**EPRI REPORT 3002025288, "ENHANCED RISK-INFORMED CATEGORIZATION  
METHODOLOGY FOR PRESSURE BOUNDARY COMPONENTS"**

**REQUESTS FOR ADDITIONAL INFORMATION (RAIS)**

Figure 1. Categorization process overview [2]

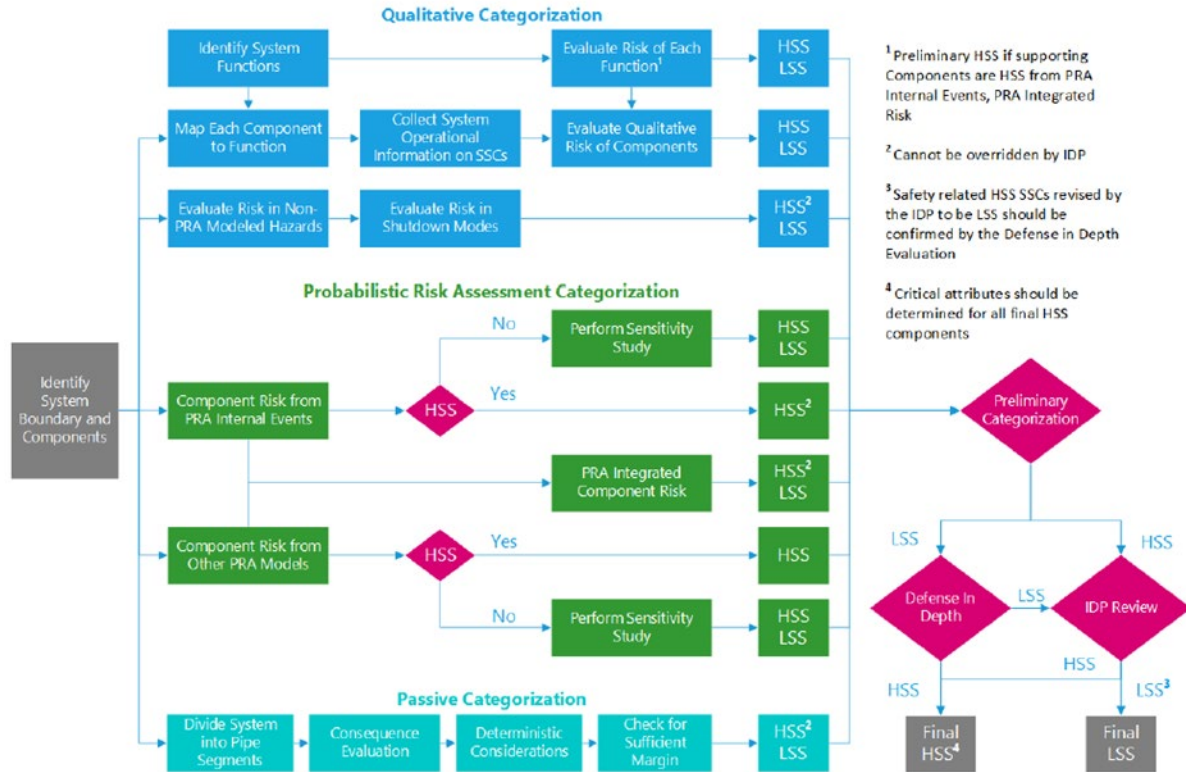
Figure 1 of the TR, “Categorization process overview”, depicts the overall 50.69 categorization process as intended to be implemented, and shows that the passive categorization is performed in parallel to the other aspects of the categorization, such as considerations based on PRA and other qualitative consideration. All these aspects are considered for the preliminary categorization step, per the guidance in Nuclear Energy Institute (NEI) 00-04 Section 7. The guidance in NEI 00-04 Section 7 states that SSCs that support multiple functions should be assigned the highest risk significant of any function that the SSC, or part thereof, supports. Finally, the inputs from the preliminary categorization are provided to the integrated decision-making panel (IDP). Table 1 of the TR states that the IDP cannot change categorization from HSS to LSS for passive components.

- b. As indicated in Figure 1 of the TR, the passive categorization is one aspect of the systematic and integrated categorization process outlined in NEI 00-04. Describe further how the passive categorization will be executed part of the overall integrated categorization process. Describe how the guidance in NEI 00-04 Section 7 for preliminary categorization will be implemented for passive components. How will all aspects of the categorization process be considered for the preliminary categorization of SSCs (both active and passive) that will be provided to the IDP?

- e. For plants which have a high seismic contribution to pipe rupture, discuss how the results of various analyses (e.g., seismic PRA, Seismic Margins Analysis) are taken into account for Criteria 11-13. If these considerations are addressed qualitatively, please explain how they will be addressed. If these considerations are addressed solely by the IDP, explain how this is communicated to the IDP and what guidance is available for the IDP.

As stated in part (a), the passive categorization will continue to follow the applicable guidance outlined in NEI 00-04, with the addition of the prerequisites, the pre-determined set of HSS components (criteria 1-10) and the plant-specific HSS criteria (criteria 11-13). TR 3002025288 does not change active function categorization.

Exercising the process in TR 3002025288 would allow for pre-determined criteria to be applied upfront to the pressure-retaining function as described in Section 4.2. When using TR 3002025288, the existing integrated categorization process (e.g., NEI 00-04) would remain in place for components with active functions (i.e., no change in the active function or the integrated approach).

As summarized in Figure 1 and Table 1 below, NEI 00-04 provides an integrated and comprehensive process for RI-categorizing SSCs that incorporates risk insights from various hazards into a final HSS / LSS determination. The enhanced methodology contained in 3002025288 provides an alternative only to that portion of the process pertaining to pressure

boundary categorization (e.g., bottom path of Figure 1 and bottom row of Table 1).
